OPERATION AND SERVICE MANUAL

8447D 8447E 8447F AMPLIFIER 0.1—1300 MHz

75. MANUAL CHANGE INSTRUCTIONS

Figure 11. 8447D/E/F Cabinet Parts

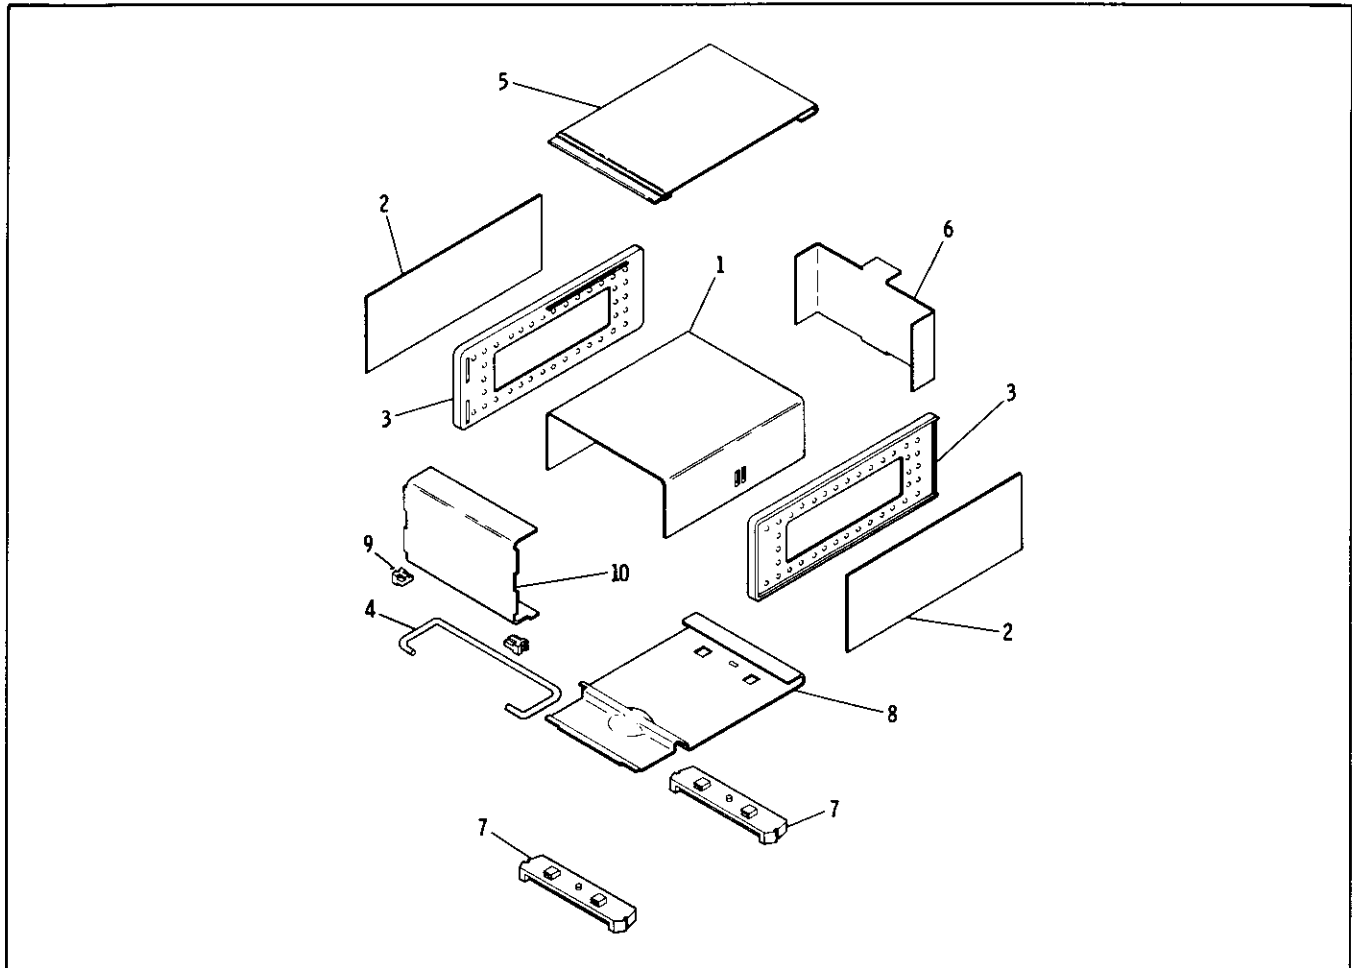
Page 24, Figure 11:

Change Index Number 6 to HP Part Number 08447-00002, Check Digit 3, PANEL REAR, Qty 1.

Page 24, Figure 11:

Delete HP Part Numbers 08447-00017, 08447-00018, 08447-00019, 08447-00021, 08447-00022, 08447-00023, 08447-00024, 08447-00025, 08447-00040, 08447-00041, 08447-00042, 08447-00043, 08447-00044, 08447-00045, 08447-00046, and 08447-00047 from Index Number 10.

Add to Index Number 10:

Page 24, Figure 11:

Delete HP Part Numbers 08447-00058, 08447-00059, 08447-00060, 08447-00061, 08447-00064, and 08447-00065 from Index Number 10.

Add to Index Number 10:

Page 24, Figure 11:

Delete HP Part Numbers 08447-00058, 08447-00059, 08447-00060, and 08447-00061 from Index Number 10.

Page 24, Figure 11:

Delete HP Part Numbers 08447-00064 and 08447-00065 from Index Number 10.

Figure 14. A1 Power Supply Component Locations

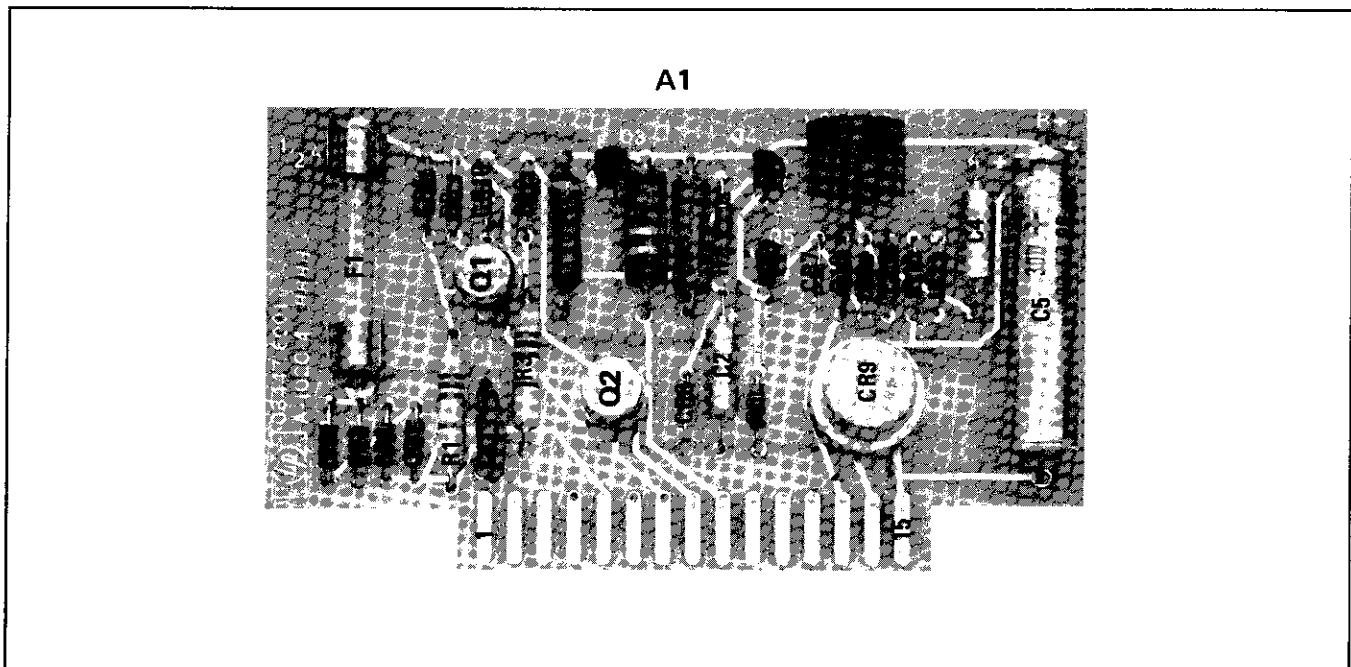
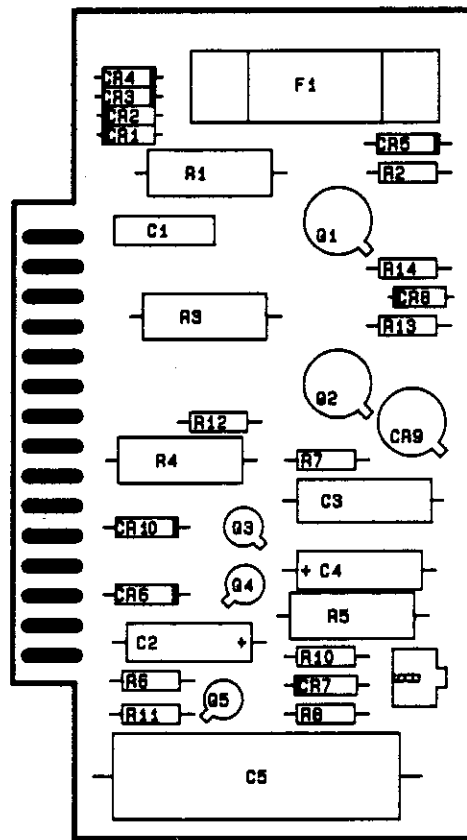
Page 27, Figure 14:

Replace Figure 14 with the new Figure 14, A1 Power Supply Component Locations (ERRATA), included in this Manual Changes supplement.

Figure 15. Amplifier and Power Supply Circuits

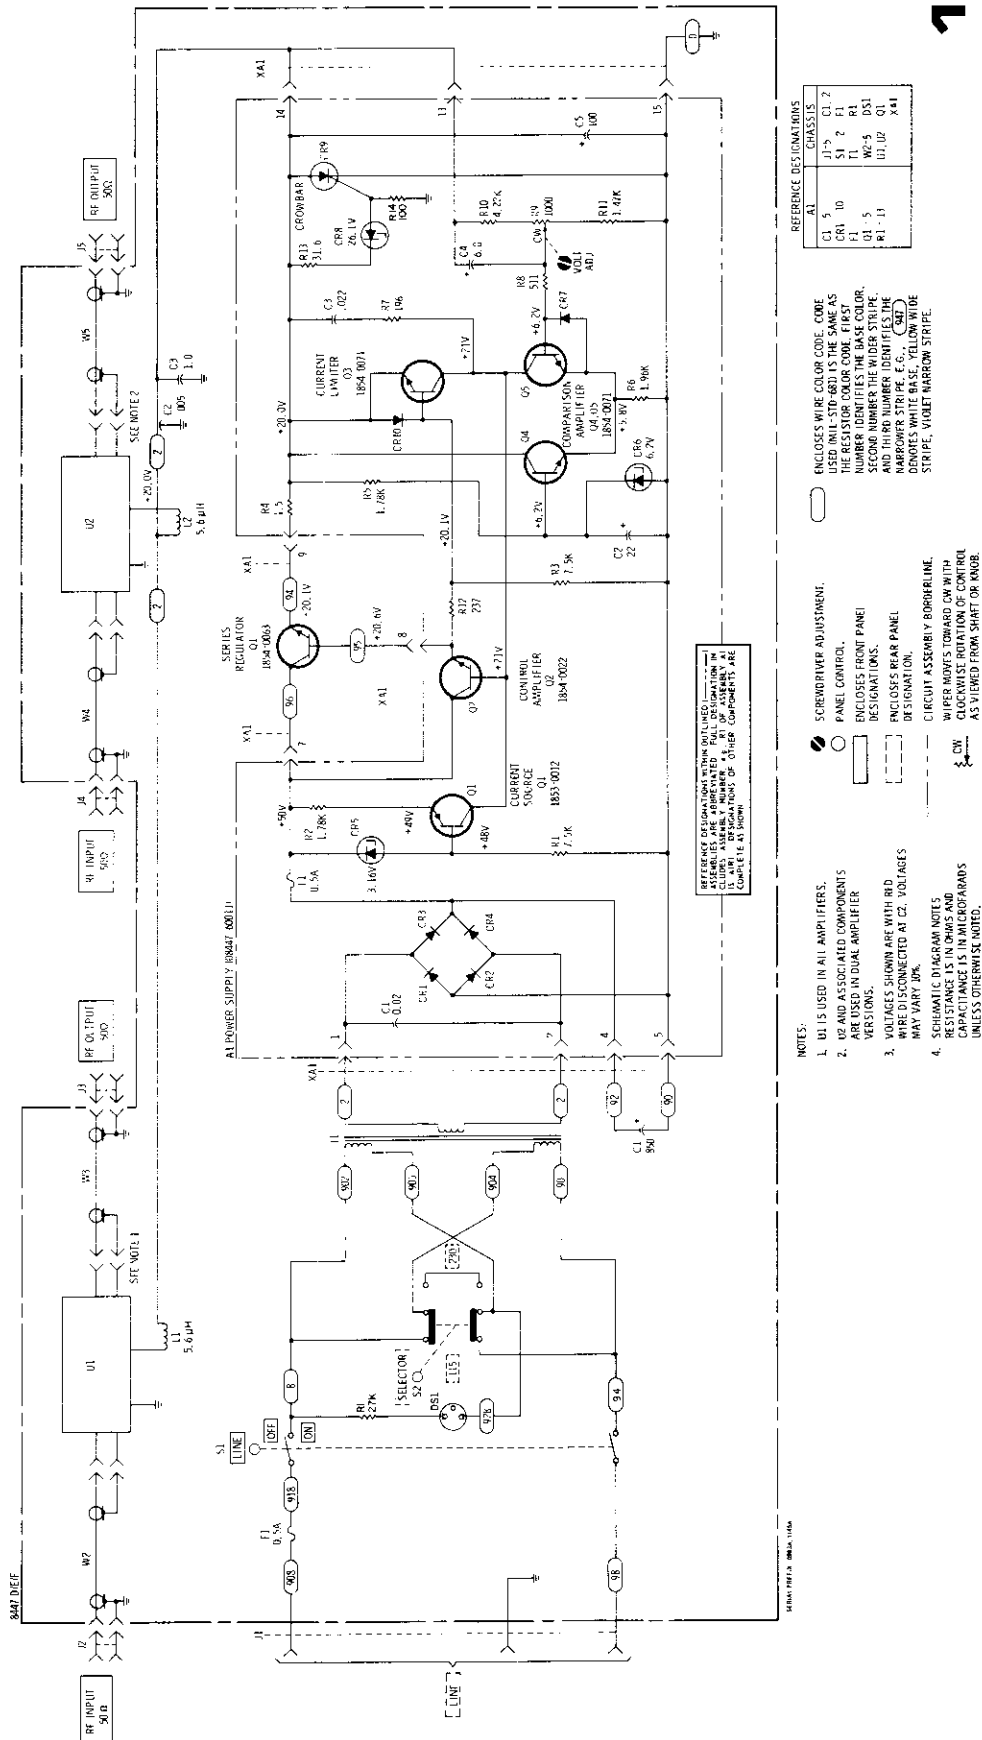
Page 28, Figure 15:

At S1 LINE switch, delete switch connection between wire numbers 98 and 94. Change wire number 94 to wire number 90 and draw a jumper between wire numbers 98 and 90.

Page 28, Figure 15:

Delete resistor R14 and its connection to ground.
